Westinghouse Electric Company LLC  
Hematite Decommissioning Project  
3300 State Road P  
Festus, MO 63028  
USA

Subject: Draft Supplemental Response to NRC Request for Additional Information on the  
Hematite Decommissioning Plan Excluding Chapter 11 (License No. SNM-  
00033, Docket No. 070-00036)

References 1 to 11 provided Westinghouse responses to NRC's Requests for Additional Information (RAIs) concerning the Hematite Decommissioning Plan (DP). This letter provides draft supplemental responses to those RAIs where NRC required clarification. These draft supplemental responses are provided in support of the scheduled June 24 and 27 conference calls identified in Reference 12.

Appendix D. Uranium Non Impacted Area Samples

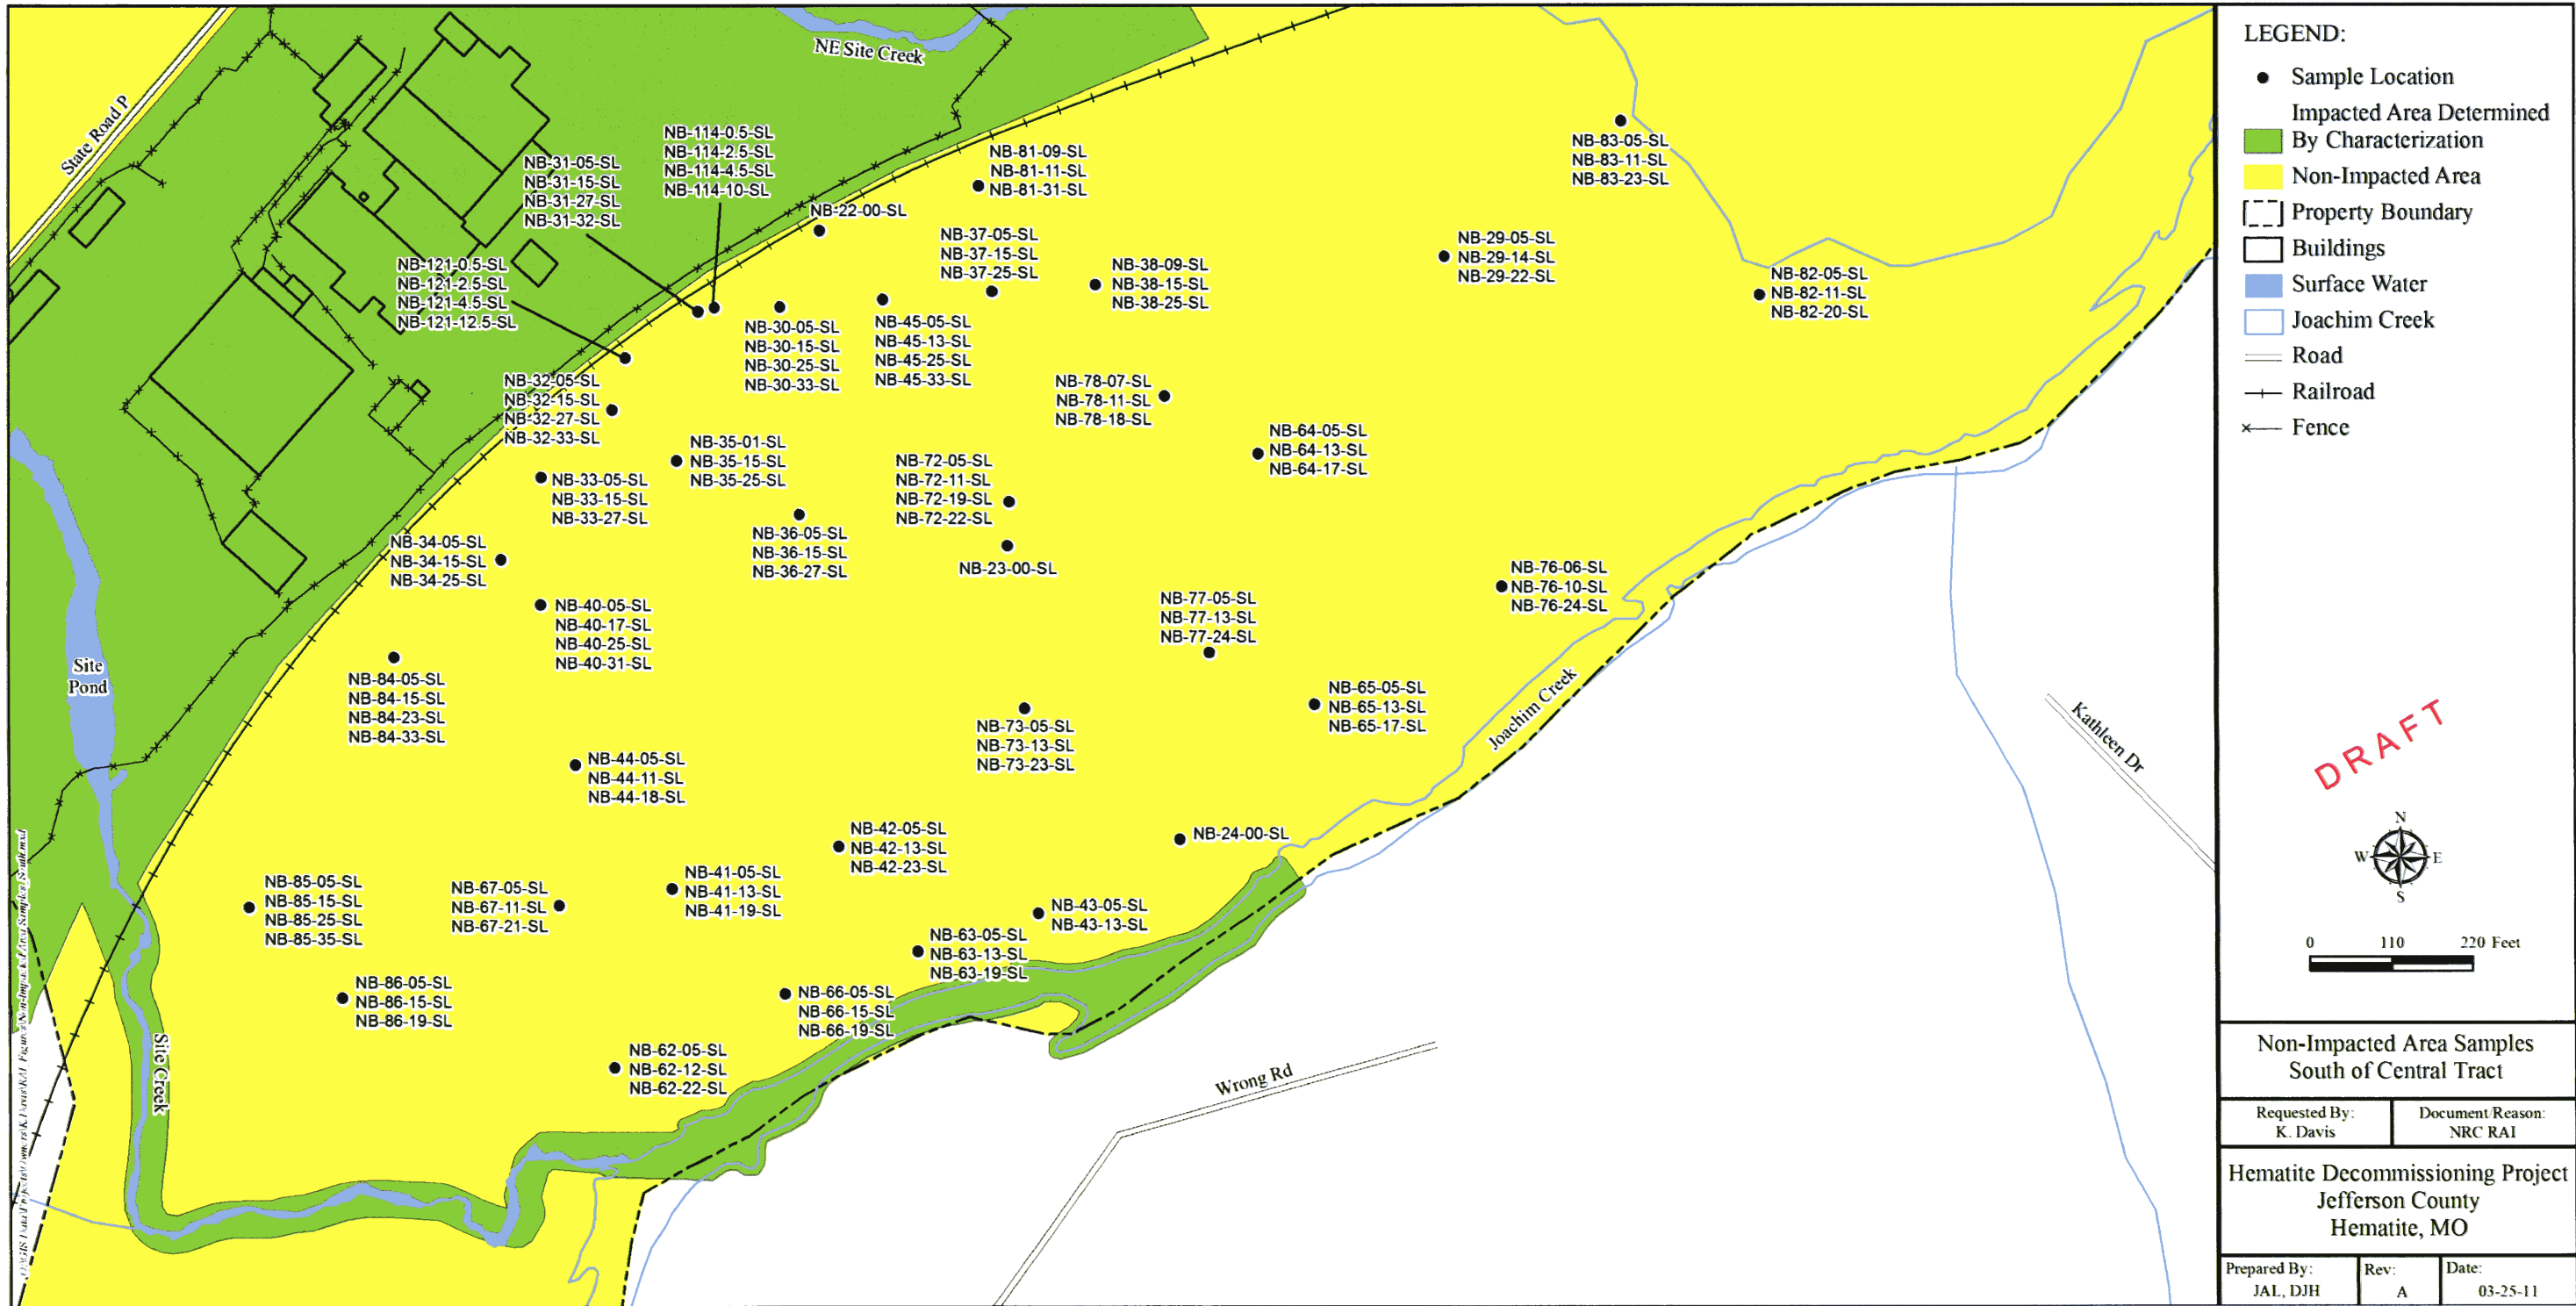
14-4c	Dismissing Quantile test results for uranium when assessing for impacted areas.	Provide detailed data used in the uranium comparison of non-impacted area to background.	This issue is being addressed in the Westinghouse response to Chapter 5 RAI additional question No. 1. Westinghouse has provided the requested data via an email (Davis to Hayes) dated 04/6/11.	Resolution of NRC comments on DP Chapter 5, RAI No. 1, and 4d below will also resolve this comment. This comment does not require its own resolution.
14-4d	Dissimilar characteristics for	Perform appropriate additional characterization to	Westinghouse has reviewed the analytical data from the surface and subsurface background	Westinghouse has provided clarifying information in the Discussion Points. No further

Sensitivity Chart of Uniform CSM DCGL vs. Increasing CZ Thickness

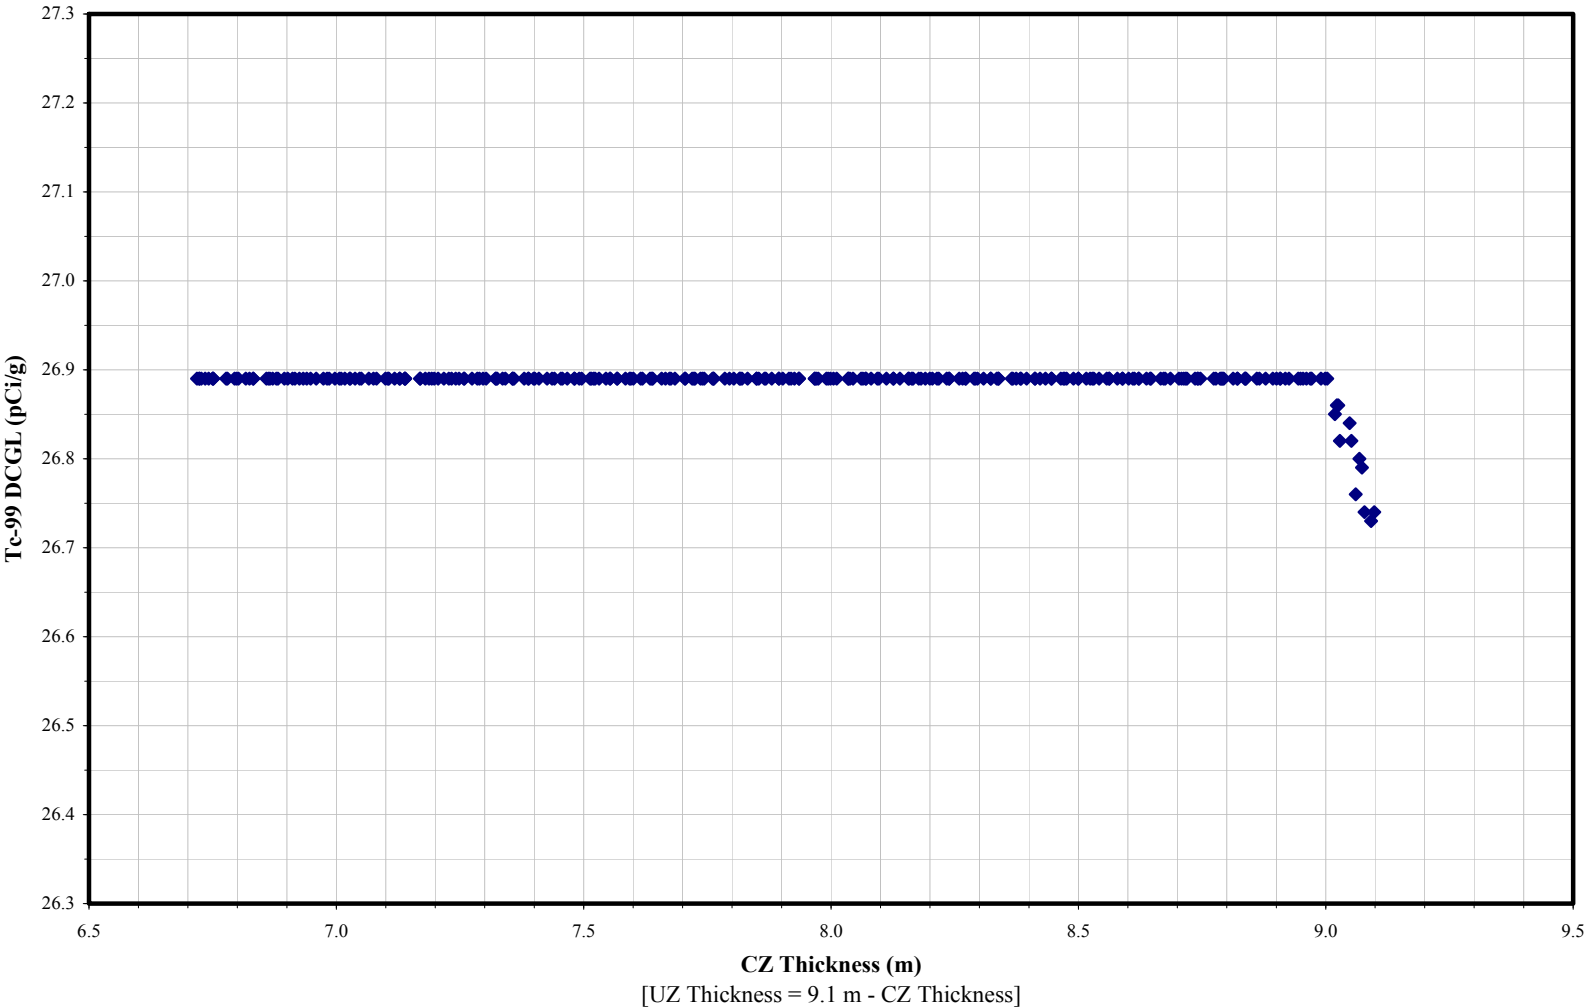
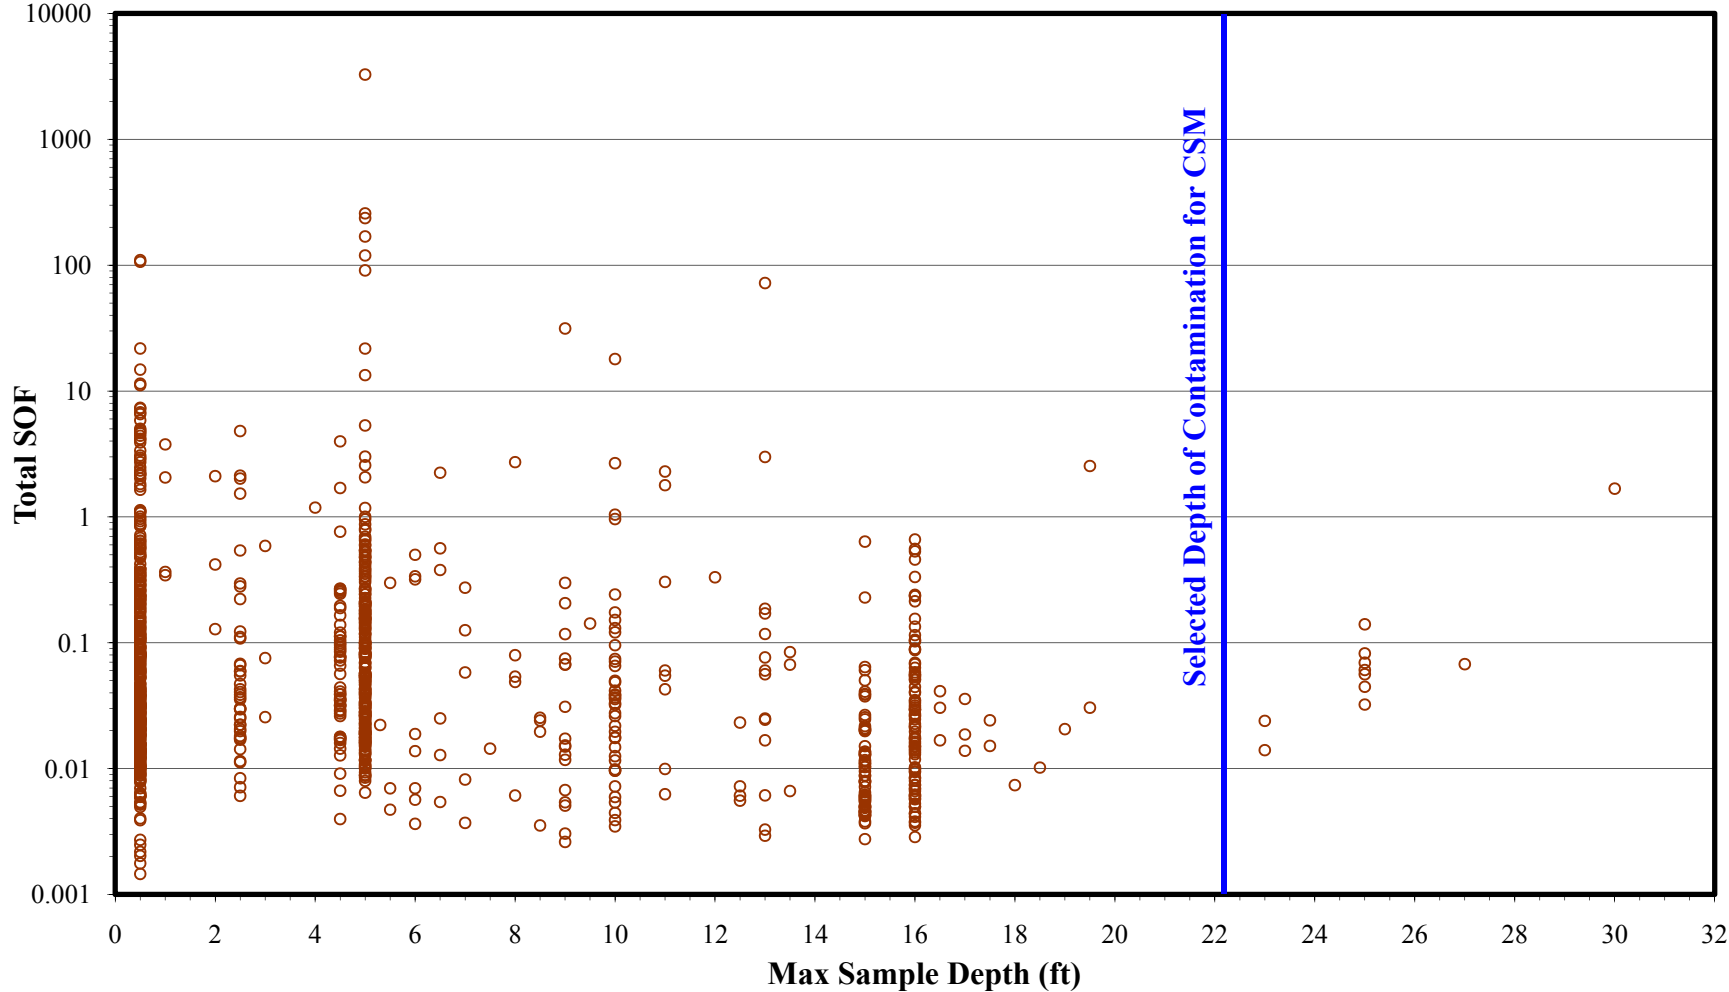
5-3	Westinghouse showed a sensitivity analysis for the Deep DCGLs but did not discuss how the Uniform DCGLs might be impacted by a similar sensitivity analysis.	1. Perform a sensitivity analysis showing how the <i>Uniform</i> Tc-99 DGCLs change with variation in the contaminated zone thickness. 2. Send an updated Figure 5-5.	1. Westinghouse has performed a sensitivity analysis showing how the Uniform Tc-99 DGCL is affected with variation in the contaminated zone thickness. The sensitivity analysis varied the depth of the contaminated zone varied from 6.7 meters to 9.1 meters, while adjusting the size of the unsaturated zone so that the sum of the two remained equal to 9.1 meters. The analysis shows that the DCGL is insensitive to the thickness of the contaminated zone. 2. DP Figure 5-5, “Depth of Soil Contamination” has been revised.	1. Appendix E shows the sensitivity chart resulting from the analysis. 2. Appendix F provides revised DP Figure 5-5, “Depth of Soil Contamination”.

**Tc-99 Excavation Scenario Concentration Resulting in 25 mrem/yr  
Comparison between DP Tables and Potential Change from Milk Transfer Factor**

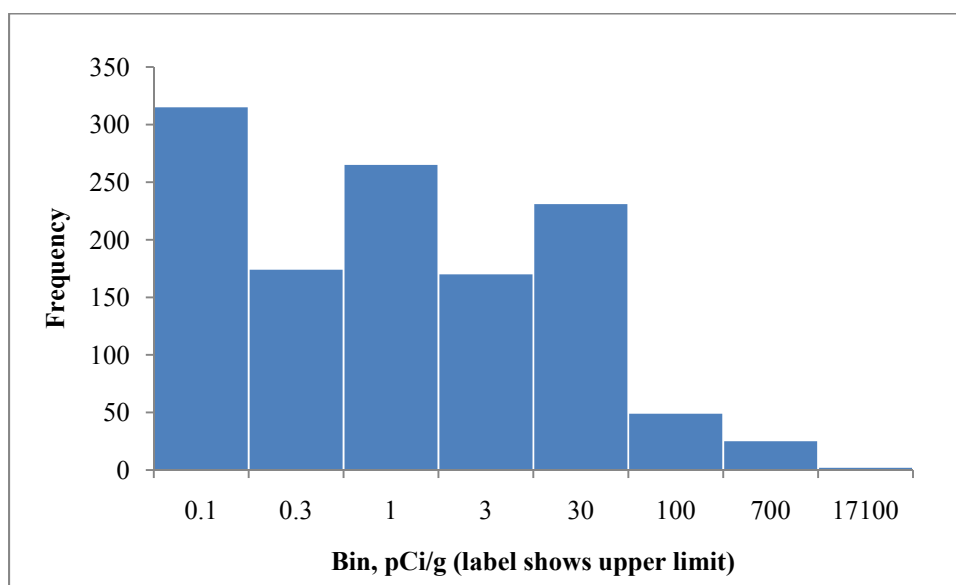
5-5	Plant transfer factors for Pa-231 and milk transfer factor for Ra need to be revised.	Provide RESRAD files with revised DCGL values after correcting for transfer factors.	In letter HEM-10-85, dated 8/11/201, Westinghouse stated the revised plant transfer factor for Pa-231 and a revised milk transfer factor for Ra-226. The revised factors are based on the median values for these factors from NUREG/CR-6697.	Appendices G and H provide the revised plant transfer and milk transfer factors in DP Table 5-6.  Appendix I provides draft revised DCGL tables; these DCGLs reflect changes resulting from the DP RAI responses submitted by Westinghouse to date, and this follow-up response.  The associated RESRAD summary files (DP Chapter 5 Appendices) will be submitted with the revision to the DP. The RESRAD summary files are in Appendix N.
5-6	Conservatism of assumed ratios of radionuclide concentrations in sensitivity analysis is not adequately justified. Some areas of the site have a higher ratio of Tc, than assumed in the sensitivity analyses (i.e., 20%) and the behavior of this radionuclide can be significantly different than other radionuclides.	Perform a sensitivity analysis assuming 100% Tc-99 to see what parameters are sensitive. If additional parameters are found to be sensitive when there is only Tc-99 present, treat these as sensitive parameters in all CSMs.	Westinghouse performed additional sensitivity analyses to provide adequate justification as follows:  1 <sup>st</sup> Step: Assumed 100% of the activity was attributed to Tc-99 to determine sensitive parameters. The analysis showed that in addition to the parameters noted as sensitive in DP Table 5-5, the Milk Transfer Factor was a sensitive parameter for the Uniform CSM. The effect on the DCGL (when recalculated using the 75th percentile of the distribution from NUREG-6697) was relatively minor, and resulted in a maximum reduction of approximately 2%. Appendix J provides the results of this 1 <sup>st</sup> Step, a comparison of Tc-99 DCGLs between the DP Tables and the potential change from the milk transfer factor, and a similar comparison among the Tc-99 excavation scenario concentrations resulting in 25 mrem/yr.	In consideration that the sensitivity for milk transfer factor had only minor impact for the 100% Tc-99 case, and was not identified as a sensitive parameter in the second assessment that was based on actual site conditions, Westinghouse will continue to treat this factor as an insensitive parameter (consistent with the sensitivity analysis presented in the DP).
